APPROVAL: [signature] 2/19/08
[1] REDLINE REVISION NO. 1 02-19-2008

US 1 (BALTIMORE AVENUE) AT MADISON STREET /CLEVELAND AVENUE

TRAFFIC SIGNALIZATION PLAN

DRAWING NO. TS-1124-D OF SHEET NO. OF

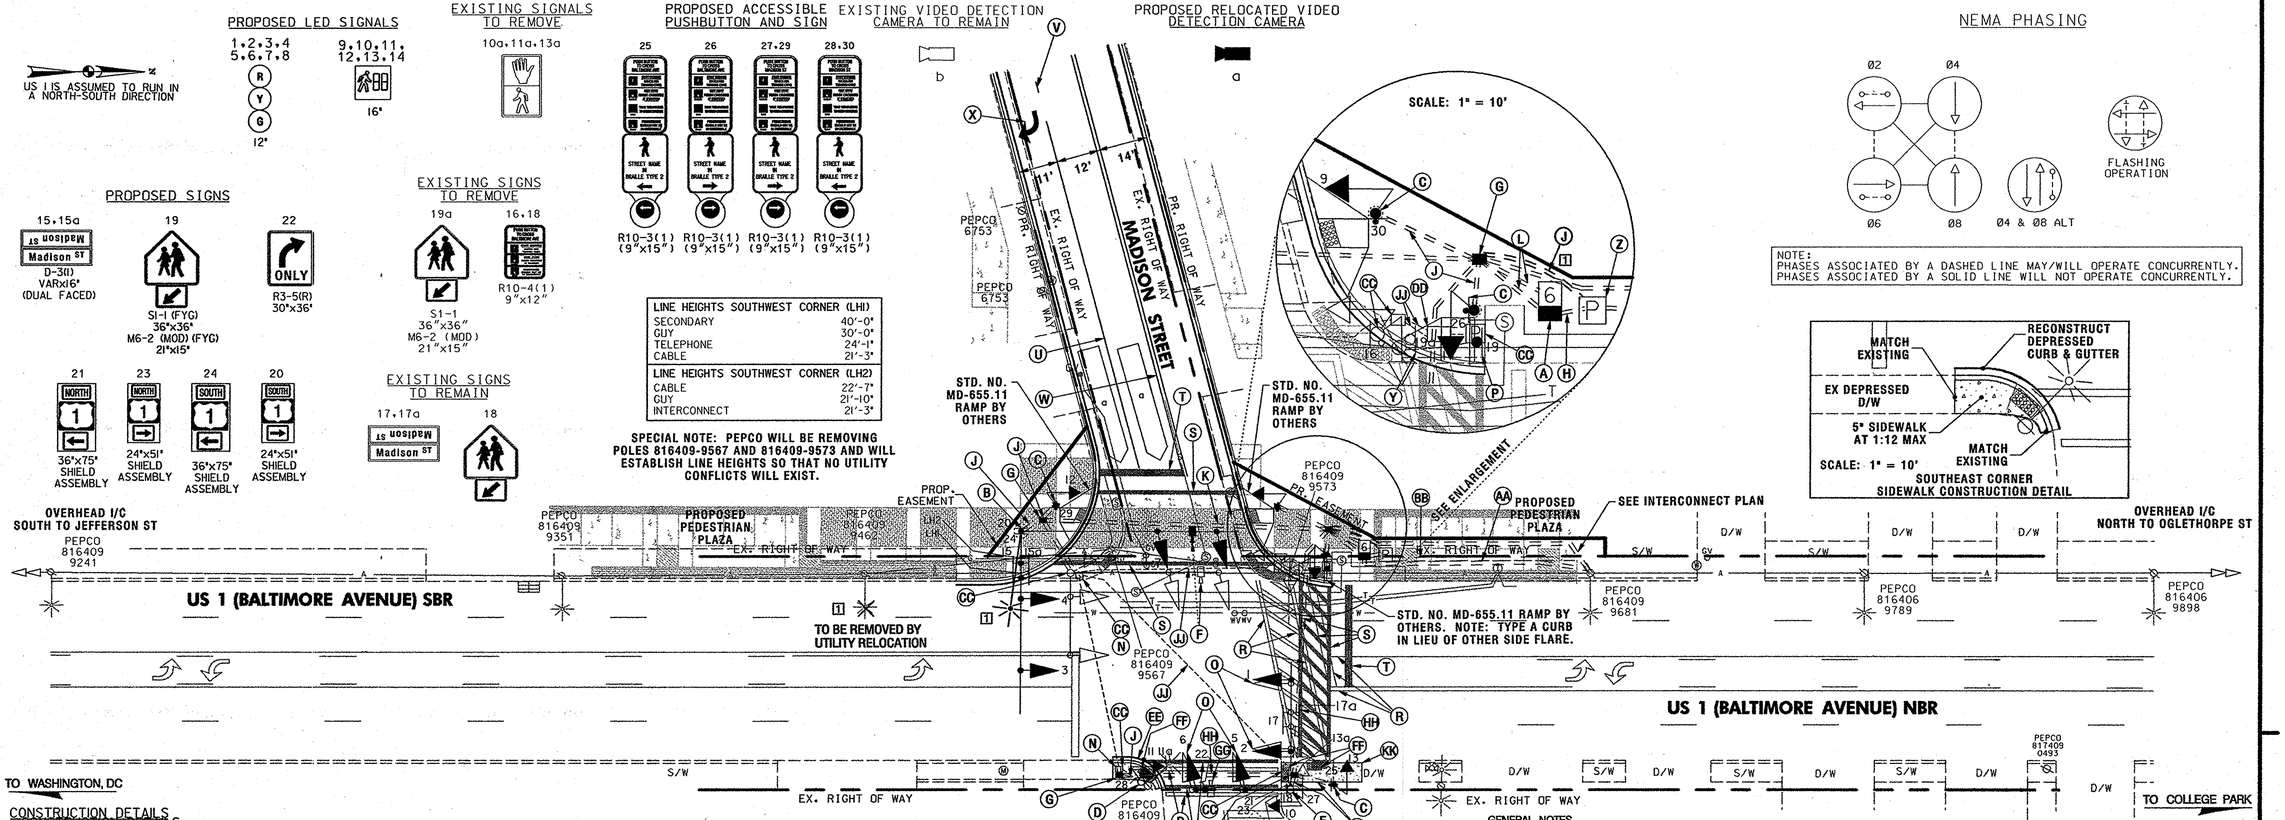
A. INSTALL EIGHT PHASE FULLY-ACTUATED CONTROLLER HOUSED IN A NEMA SIZE 6 BASE MOUNTED CABINET WITH ALL OF THE NECESSARY EQUIPMENT (NOTE: 2-2 IN. AND 2-4 IN. PVC 90 DEGREE BENDS) (NOTE: USE PROPOSED SIDEWALK AS COURTESY PAD)
[1] 27 FT. 20 FT. LIGHTING ARM WITH 250 WATT HPS LUMINAIRE

B. INSTALL ~~21 FT.~~ STEEL POLE WITH TWIN 50 FT./60 FT. MAST ARMS, FOUNDATION, TRAFFIC SIGNAL HEADS, RELOCATED VIDEO DETECTION CAMERA (INSTALL NEW CONTROL CABLE), SIGNS, (NOTE: 2-3 IN. PVC 90 DEGREE BENDS (ONE BEND FOR FUTURE USE)) (THE 60 FT. ARM IS FOR THE WESTBOUND APPROACH)
